**PUTTAGHAN LANDS, WELLWOOD, TULLAMORE**  
FURTHER INFORMATION REQUEST ARCHITECTURAL REPORT

ARCHITECT'S REPORT  
OCTOBER 2023

Figure E1 south west corner - previously submitted site layout plan

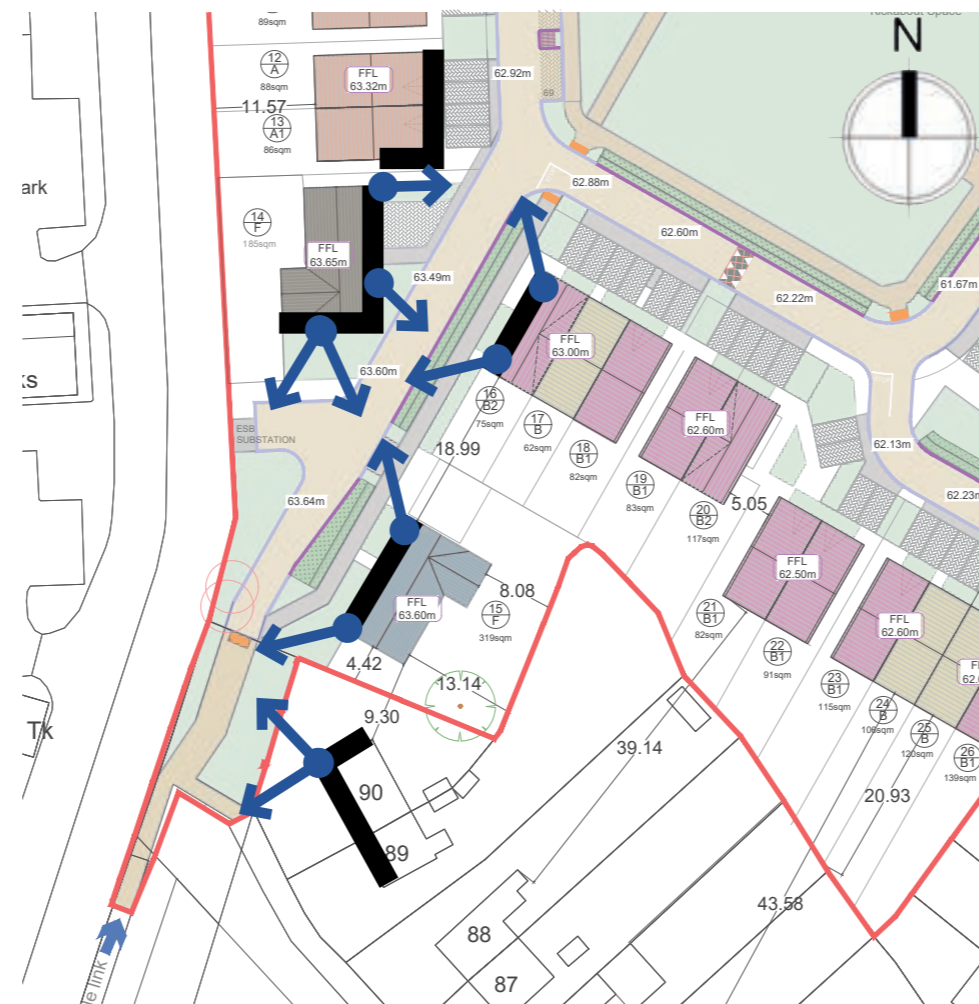
**1e** - The Planning Authority has concerns regarding the lack of passive surveillance of Thornsberry/ Park Avenue interface area. In this regard the applicant is requested to submit a revised design omitting units 14 and 15 and submitting a revised proposal for dwelling(s) facing the Thornsberry/ Park Avenue interface area

To enhance passive surveillance in this region, the previously proposed units 14 and 15 of type C have been substituted with a type F dwelling. This housing design offers a unique advantage with its dual main facades set at a 90-degree angle, effectively turning the corner and harmonizing with the envisioned shared surface and public space.

The newly envisioned urban layout guarantees the elimination of obscured zones, thereby maintaining a seamless public-private interface with a vigilant "eyes on the street" concept. This concept is illustrated in the adjacent figures E.1 and E.2.

2 TIER BIKE STORAGE SYSTEM EXAMPLE  
1:100

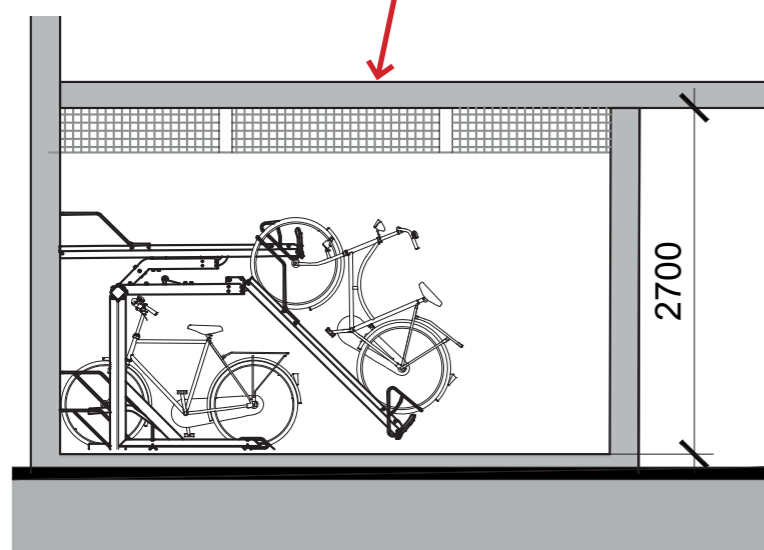
**1j** - The applicant has indicated that 70 bicycle spaces are proposed in the Schedule of Accommodation ref no 18037. This does not appear to meet the requirements of DMS-99. The applicant is invited to address this discrepancy.

The number of bike parking provision was increase to 84no. In total, which exceeds the required minimum provision in the Offaly County Development plan objective DMS-99 as demonstrated in figure J.3 adjacent.

The newly proposed bike parking includes a two tier arrangement in the larger space in block A as demonstrated in figure J.2 adjacent and a single tier arrangement in block B which will be easily accessible to the age friendly unit dwellers

Figure K.1 Extract from car parking strategy drawing

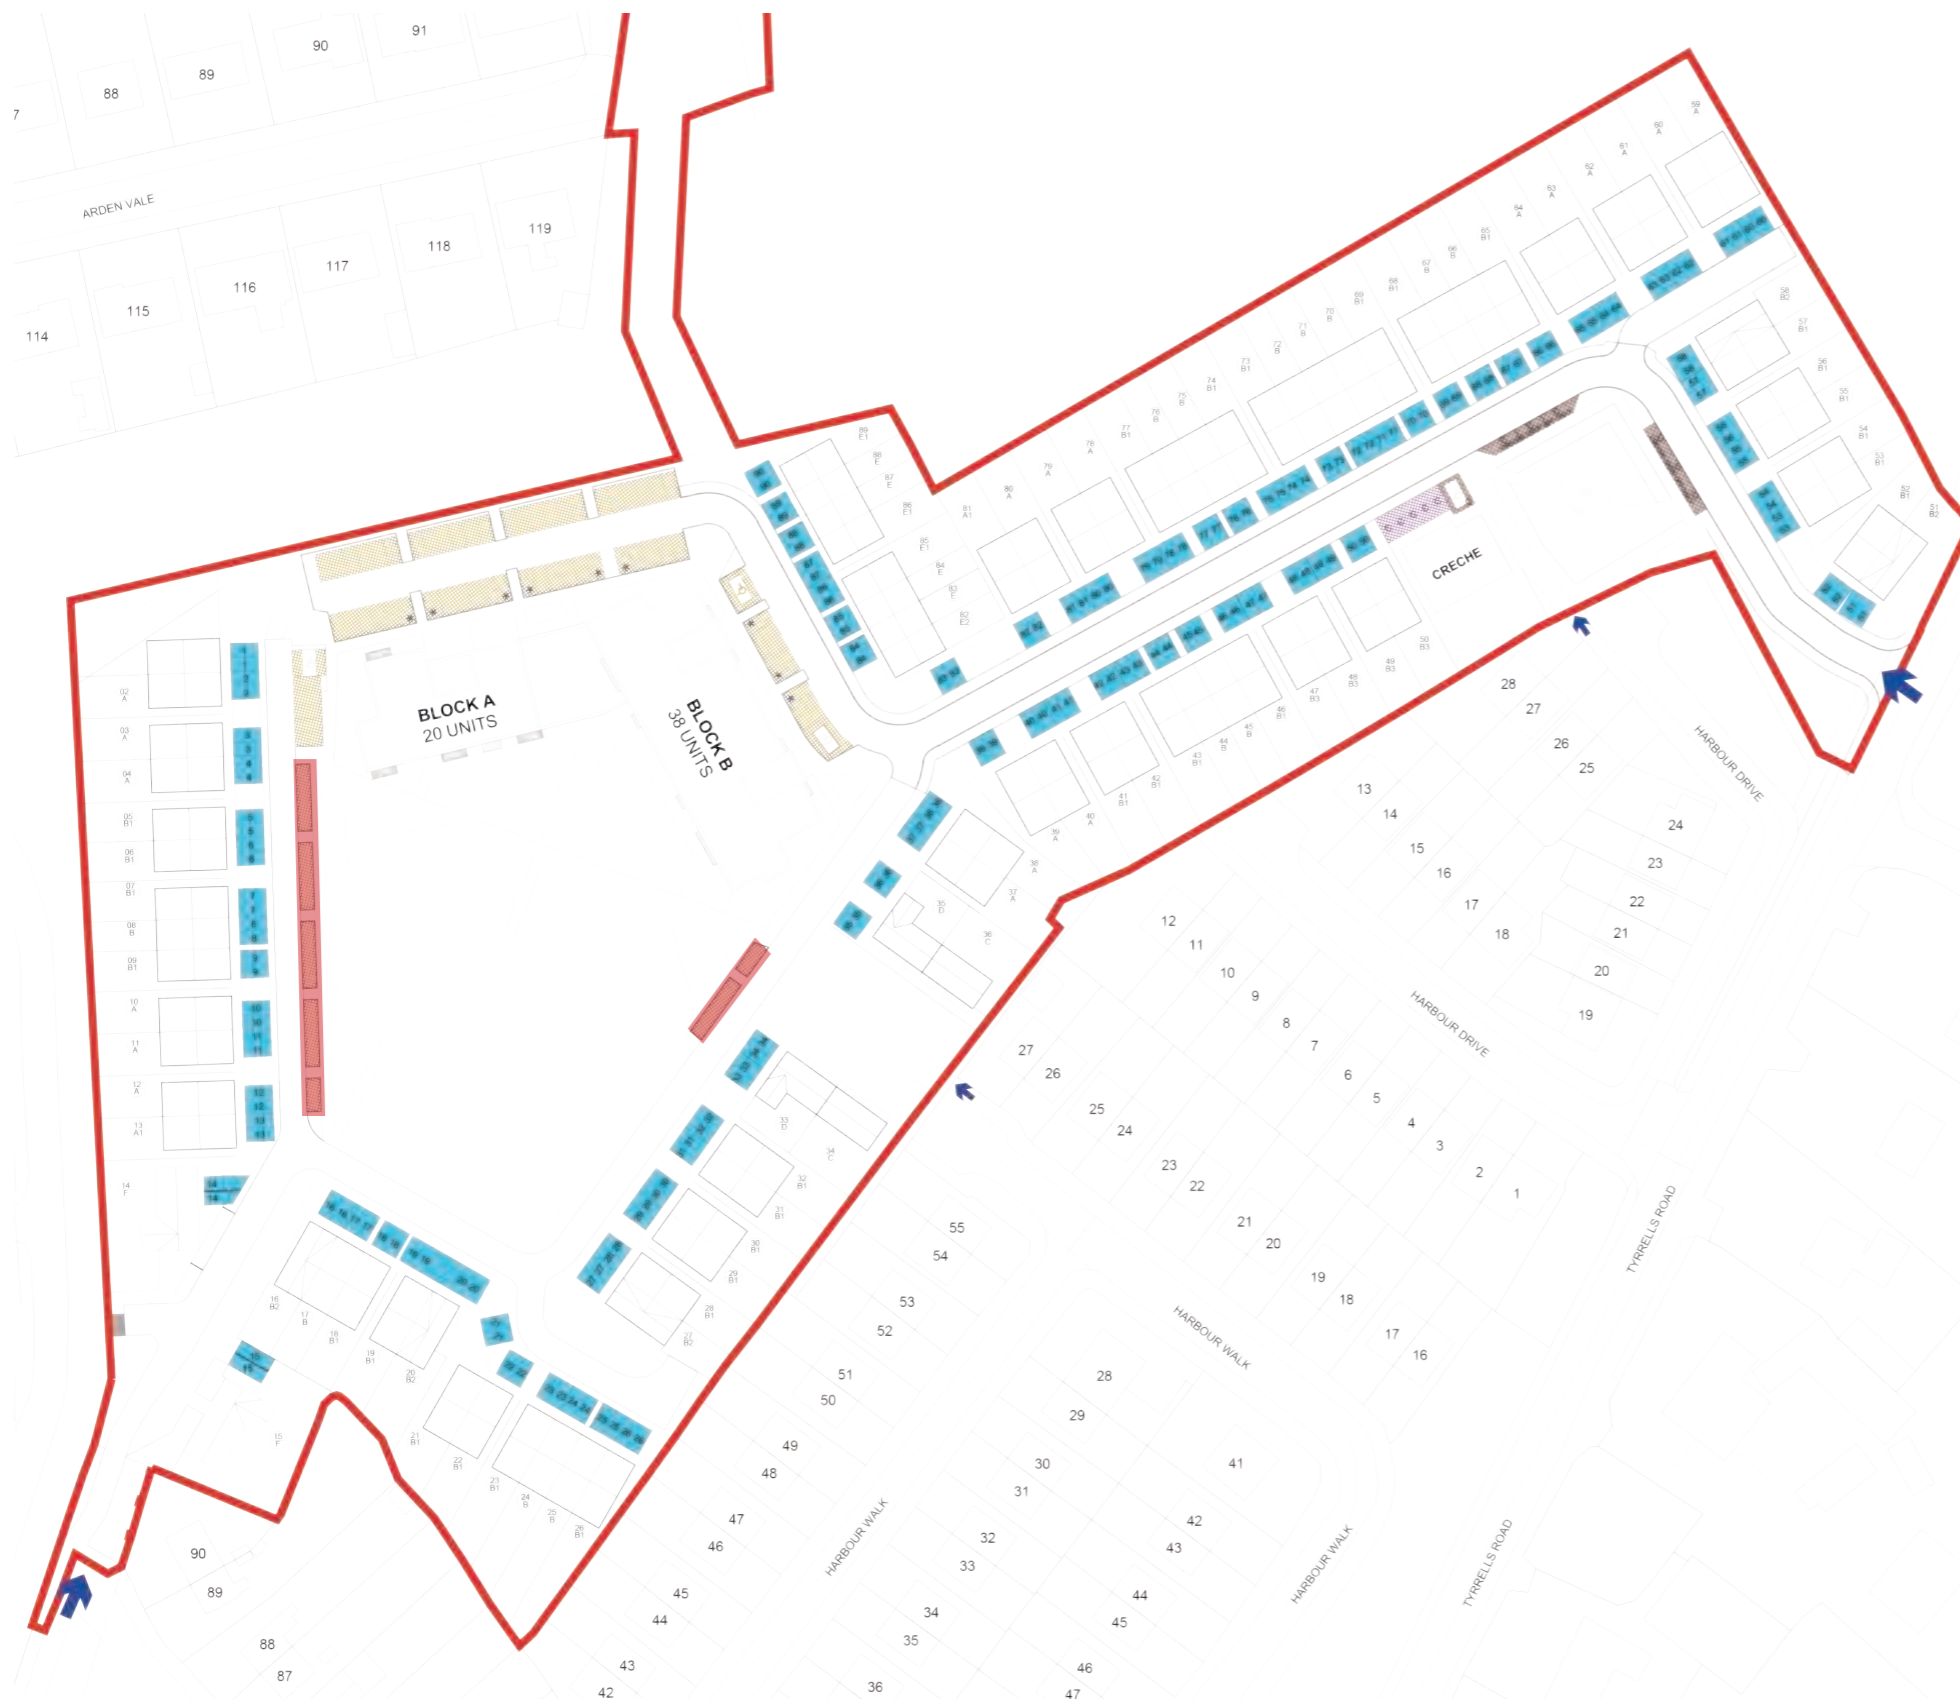
**1k** - It is noted that DMS-102 would require 70 car parking spaces for the apartments but only 63 are provided for. It is considered that additional spaces, adjoining public open space one, should be provided

Proposed enhancements include the introduction of supplementary car parking spaces, clearly demarcated, which intersect with the primary Public Open Space, as visually indicated in Figure K.1 depicted in red.

These revised parking figures align with the stipulated minimum requirements outlined in the Offaly County Development Plan under objective DMS-102.

Figure O.1 - Bin store mid terraced houses

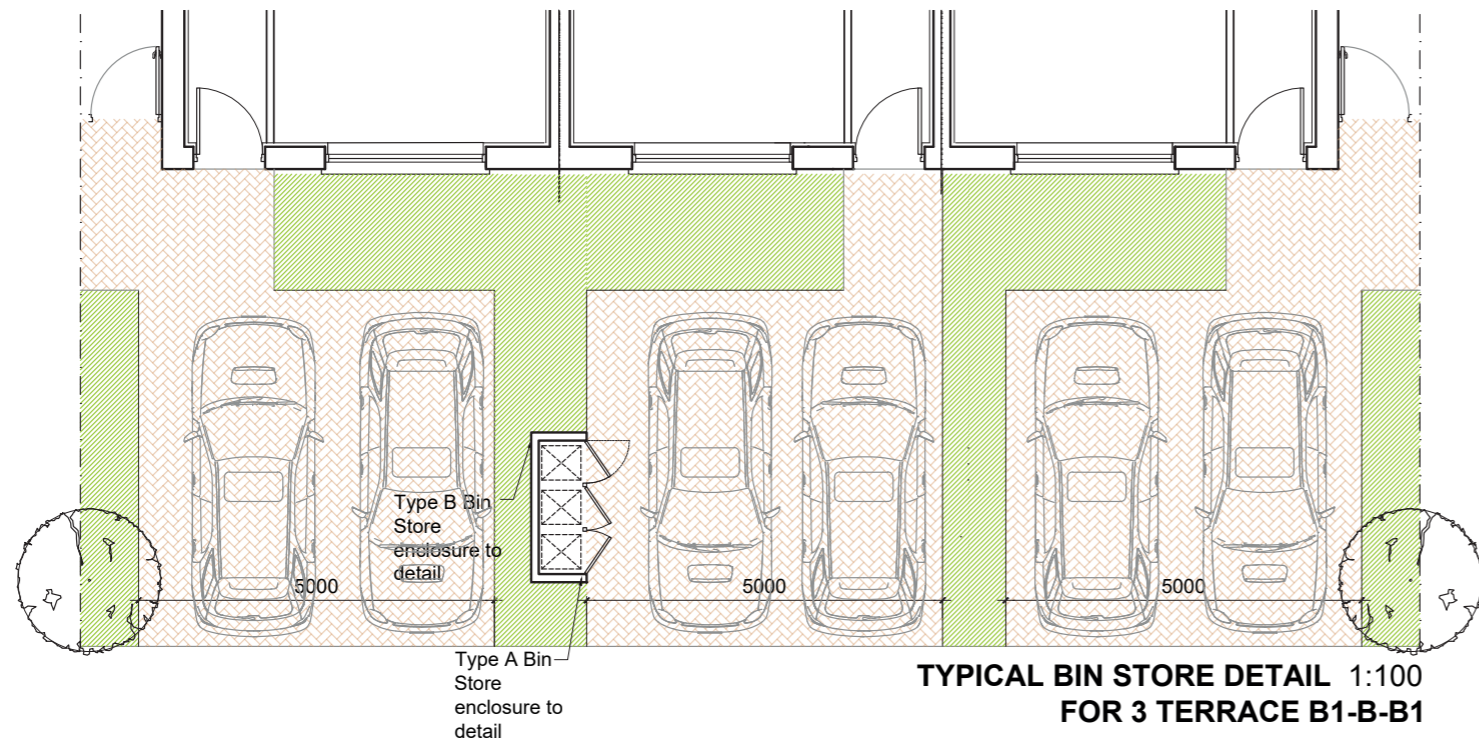
**1o** - Having regard to the elevation treatments of bins and front garden shown on drawing PL113 please demonstrate that bins can be opened when cars are parked.

The bin store design is now updated to have three doors instead of two which will ensure practical manoeuvring areas when cars are parked adjacent.

Figure 6.1 - Extract day light / sun light analysis

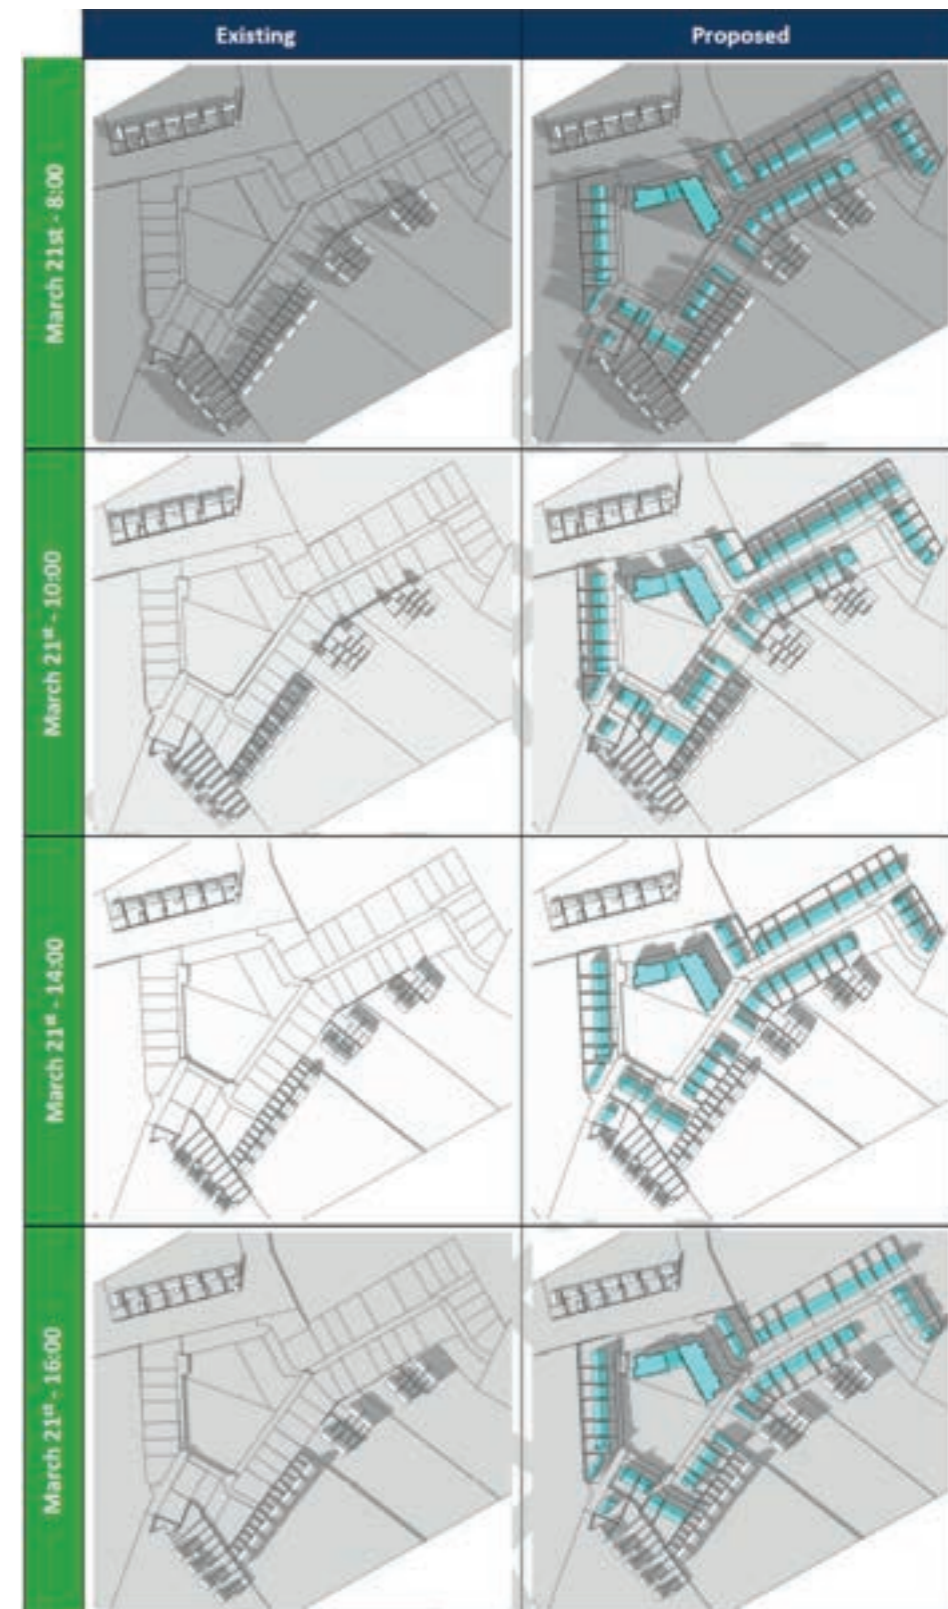
**6** - The applicant should note that a number of third party submissions are on file and the applicant is invited to address the issues raised. In this regard please submit photomontages of the proposed apartments as seen from the rear gardens of dwellings in Arden Vale.

Full verified CGI's are submitted with this application with additional views from the relevant locations. The balconies of units 90no, 95no, 100no and 105no have been updated to face west, which combined with the current proposed separation of over 60m. between proposed and existing building, will ensure optimum quality in private amenity areas, both existing and proposed.

Additionally, a full day light / sun light assessment of the proposed development is submitted which concludes the following:

The report concludes that none of the neighbouring buildings need to be included in the VSC assessment as there is no obstruction, measured in the section perpendicular to the window wall, no angle subtends an angle of more than 25° to the horizontal. This, according to the BRE guide means that the adjacent dwellings do not have to be included in the daylight assessment.

The report concludes that the development will have a no virtually impact on existing buildings, with only minimal shading observed in the surrounding residential estates as described in section 5.3 of the Daylight and Sunlight report

The report concludes that all open spaces, Public and communal, meet and in most cases greatly exceed the relevant BRE guidelines.

The report concludes that of the 68 no. points tested, 68 no. points (100%) meet the BRE Guide 3rd Edition / IS EN 17037-2018+A1-2021 sunlight exposure recommendations of greater than 1.5 hours on March 21st, meaning that the proposed buildings are performing well from a daylighting perspective.
